Report of the Head of Planning & Enforcement Services

Address 16 AND 18 KINGSEND RUISLIP

LBH Ref Nos: 63221/APP/2012/878

drawing scale:	1:100 @ A3	checked
drawn by:	10 May 2012	
date:		
job no.:	11031 - 123 B	revision

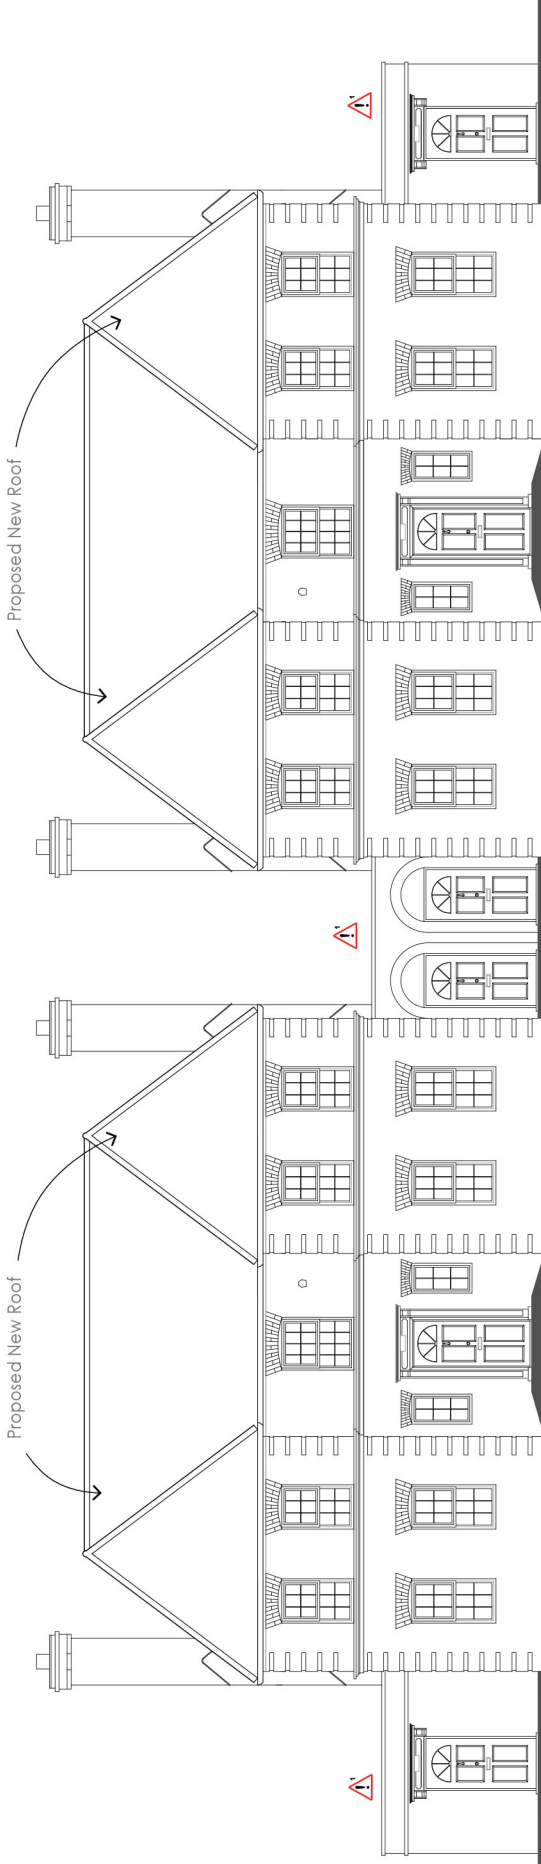
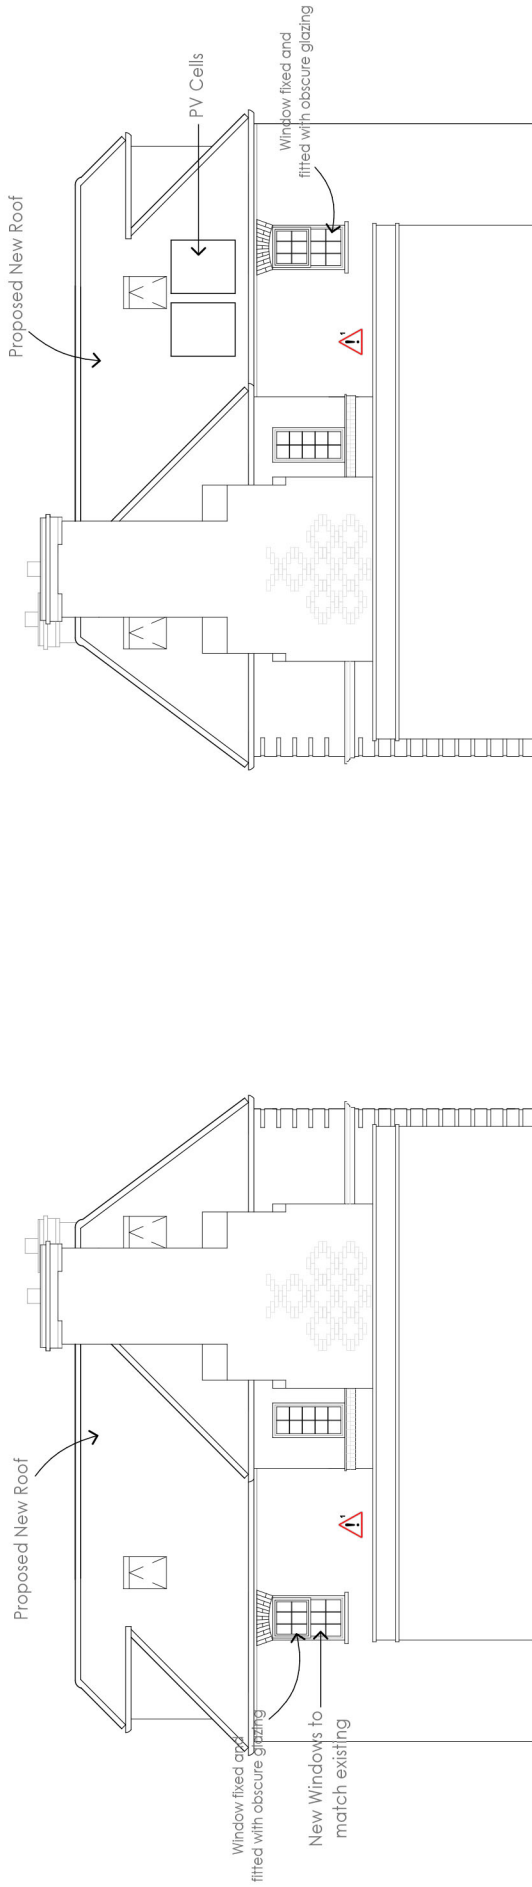
a) Street elevation: It is proposed to replace the roof and to raise the ridge and eaves lines, the latter by the incorporation of brick arches over the first floor windows. To assess the impact of these changes on the streetscape, the height of the adjacent structures needs to be shown on the drawings, ideally a streetscape drawing should be included. The new roof should replicate the features of the old in terms of the type of tiles used (possibly salvaging the existing tiles and using traditional the bonnet tiles) and the existing sprocketed eaves detail. As a part of any enhancement associated with this development, appropriately designed and detailed windows in timber would be required (all elevations) together with replicas of the original timber 6 panel front doors, as opposed to the modern Carolina style doors shown. The doors to the side of the original main entrances should be recessed and of a more simple, but traditional design e.g 4 panels with a brick arch over as existing, rather than a pediment/canopy as shown.

When viewed from the street it is considered that the proposed doors to the side of the original main entrances should be recessed and of a more simple, but traditional design for example comprising four panels with a brick arch over as existing, rather than a pediment/canopy as shown on the plans.
